**City of Portland, Maine – Building or Use Permit Application** 389 Congress Street, 04101, Tel: (207) 874-8703, FAX: 874-8716

Location of Construction: 44 Alice Court (Auburn Pines Subdivision)		Owner: Busque Construction Co, Inc. 43 Cottage Ave. Windham, ME 04062		Phone: 207-893-1200		Permit No: <b>991200</b>	
Owner Address:		Lessee/Buyer's Name:		Phone:		BusinessName:	
Contractor Name: Busque Construction Co. Inc.		Address: 43 Cottage Ave. Windham, ME 04062		Phone: 207-893-1200		Permit Issued: <b>NOV - 1 1999</b>	
Past Use: Vacant		Proposed Use: Construction of new 1-Fam. with attached 2 story garage.		COST OF WORK: \$ 160,000.00		PERMIT FEE: \$ 984.00	
				FIRE DEPT. <input type="checkbox"/> Approved <input type="checkbox"/> Denied		INSPECTION: Use Group: A3 Type: 5/3 000496	
Proposed Project Description: Construction of single family with attached two story garage.				Signature:		Signature:	
				PEDESTRIAN ACTIVITIES DISTRICT (P.A.D.)		Zoning Approval: Special Zone or Reviews: <input type="checkbox"/> Shoreland <input type="checkbox"/> Wetland <input type="checkbox"/> Flood Zone <input type="checkbox"/> Subdivision <input checked="" type="checkbox"/> Site Plan maj <input typ

# Dormer Cross Section

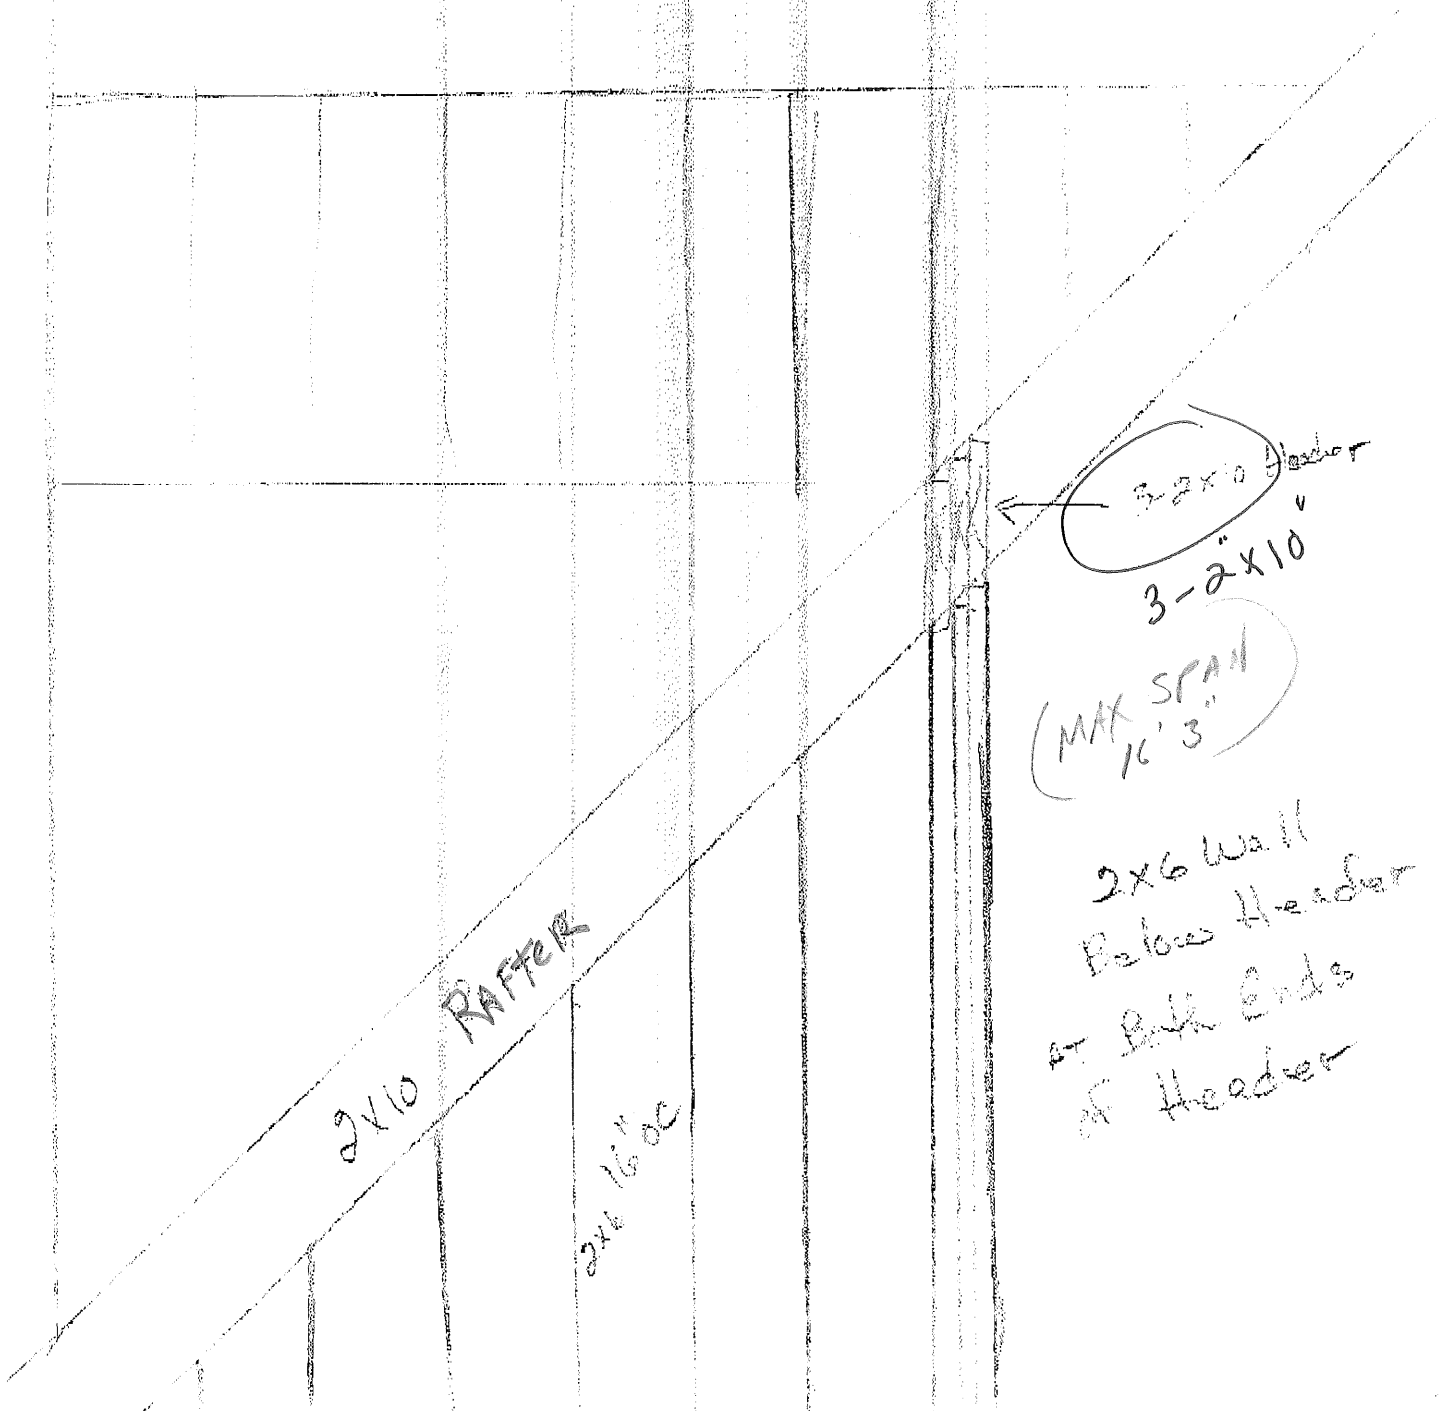
- 3/2/00 - Called for Clouse - Not Ready - Bldg will supply detail drawing of front Dormer - joints over Bulkhead not supported - discussed feral dimension of truss/passers  
 "Al" Carpenter says he can meet code - some split rafters on dormer must be replaced

- 3/3/00 - Rump for close - ok except for Room over garage which will be left unfinished - still need detail drawing on Dormer & Specs on GMS
- 3/6 - Specs on Dormer rec'd, submitted to PSH - NEED DESIGN PROFESSIONAL  
 SEAL & SIGNATURE

**SINGLE FAMILY RESIDENCE PLOT PLAN**  
 OF:  
**LOT 19 AUBURN PINES SUBDIVISION**  
 AUBURN PINES DRIVE  
 PORTLAND, ME  
 FOR:  
**BUSQUE CONSTRUCTION COMPANY, INC.**  
 43 COTTAGE AVE.  
 WINDHAM, ME 04062

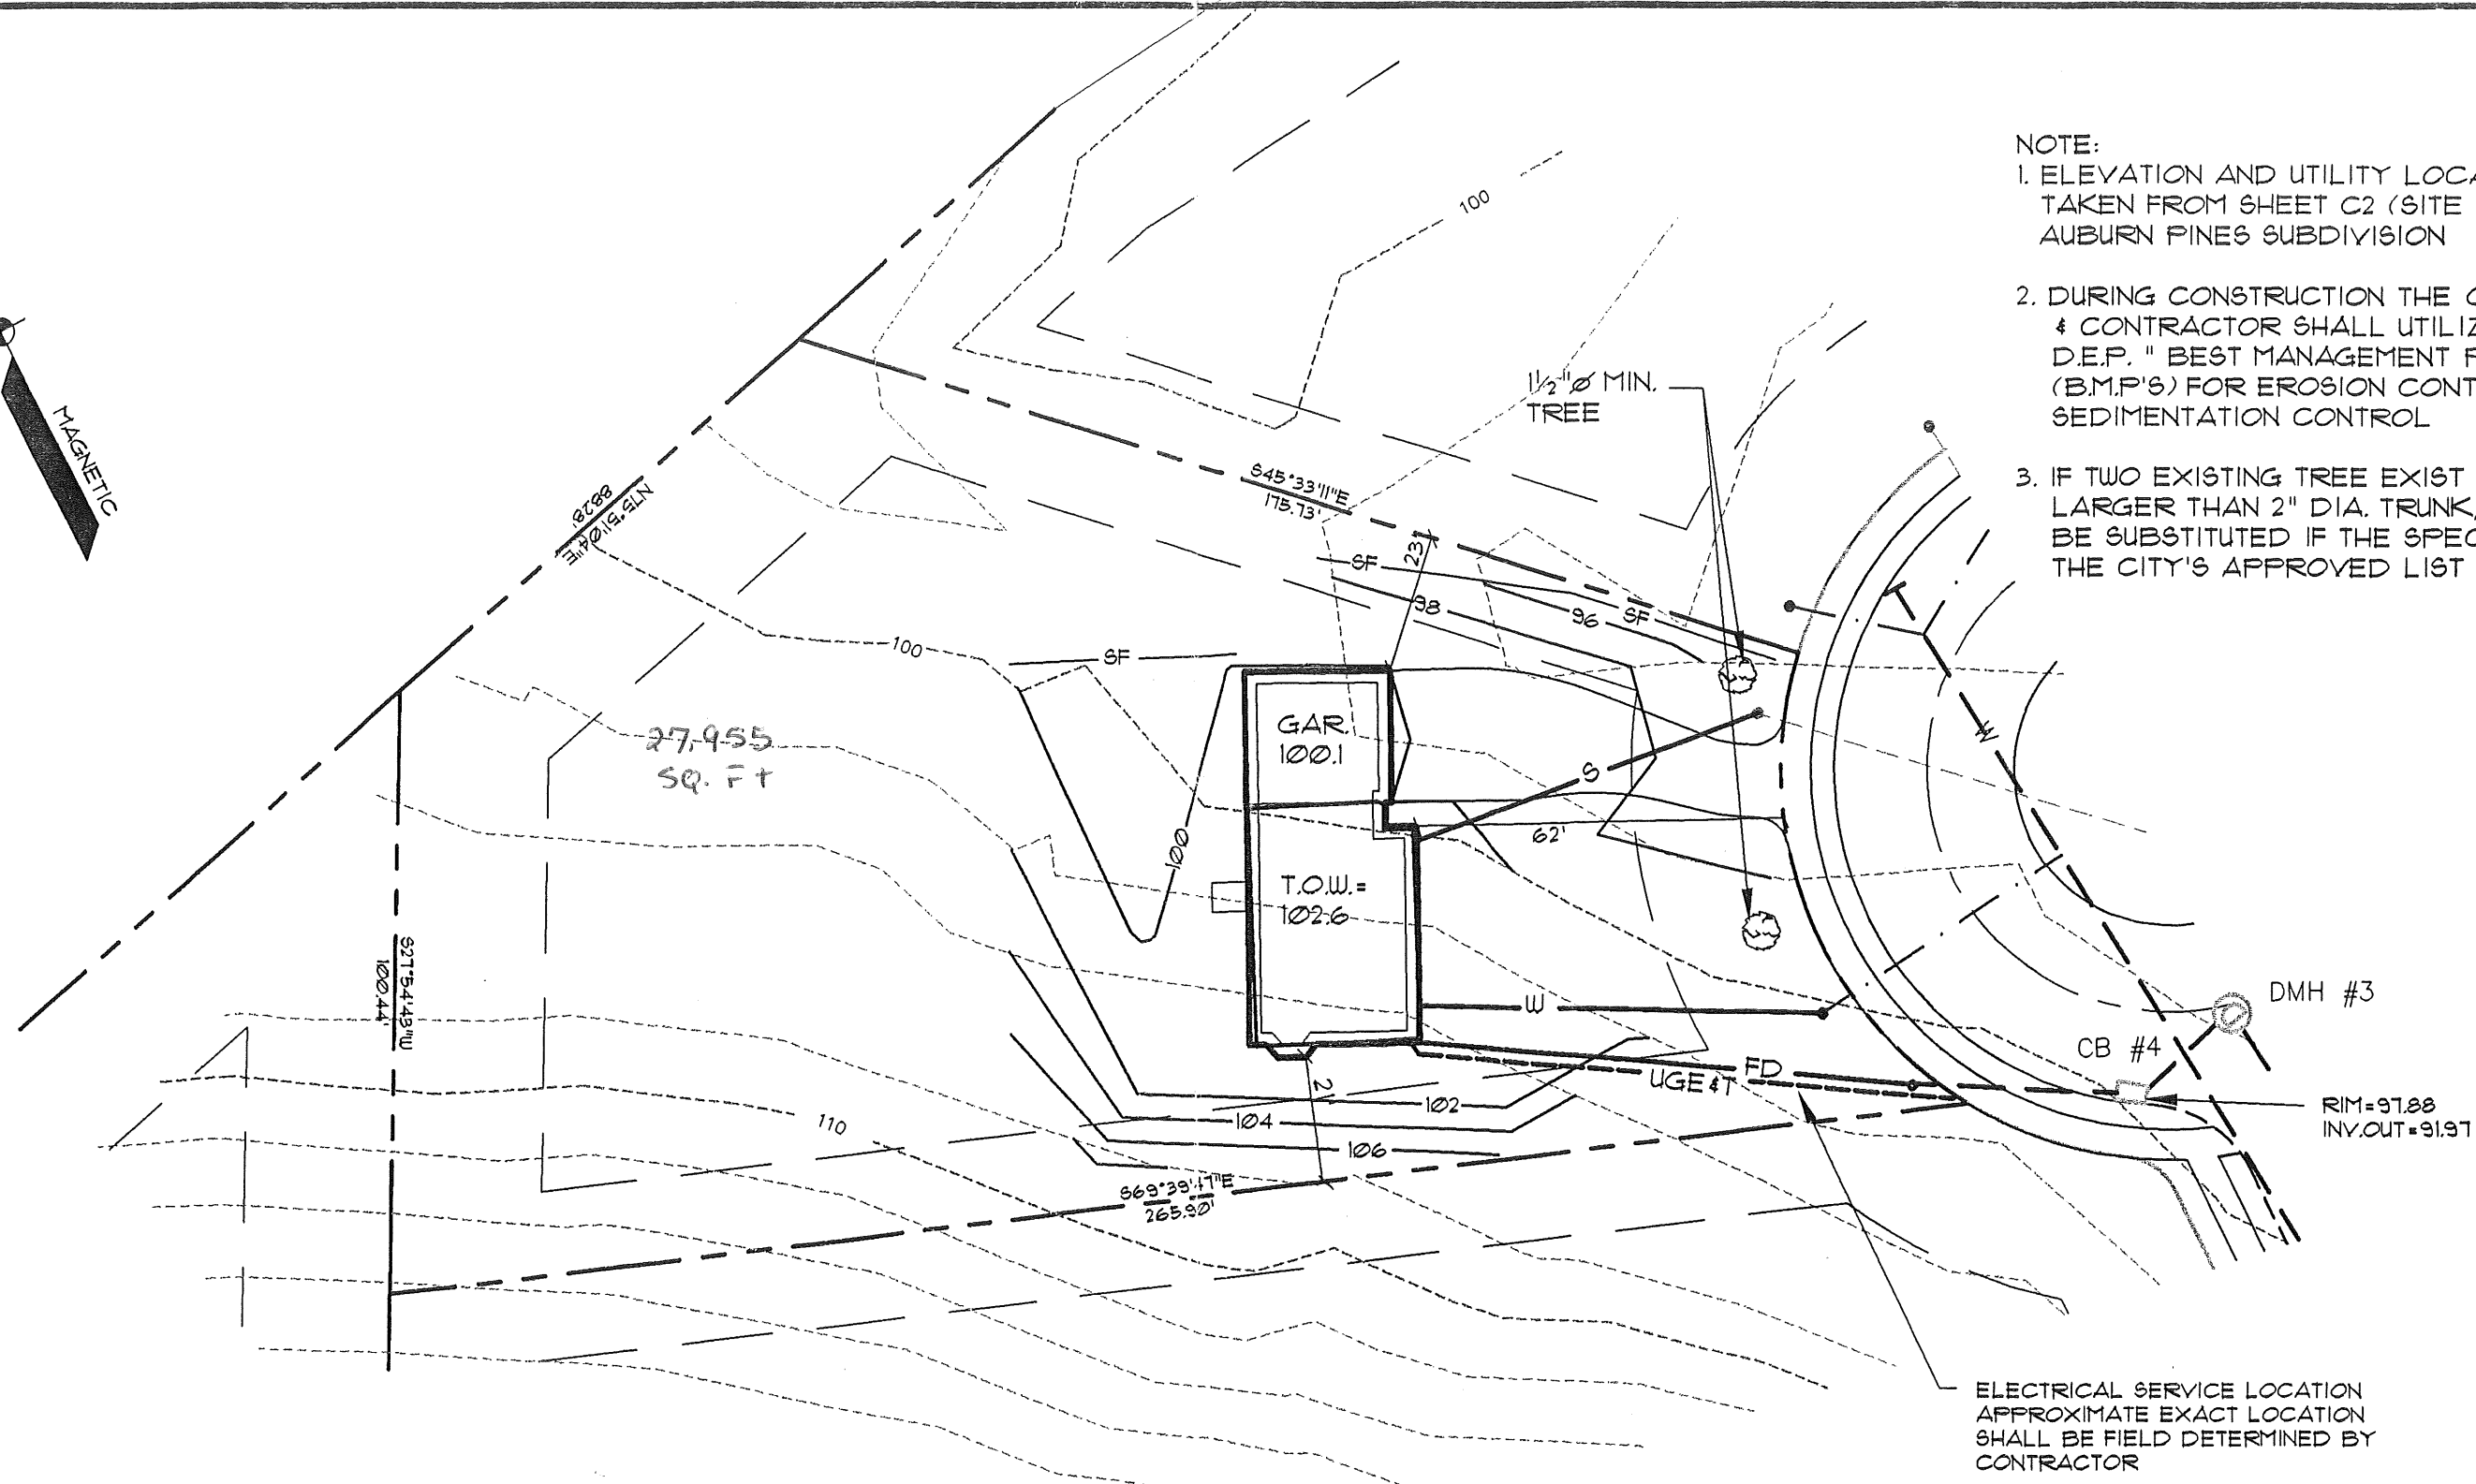
31. Please read and implement the attached Land Use Zoning report requirements. *see attached site plan sheet APPROVED*
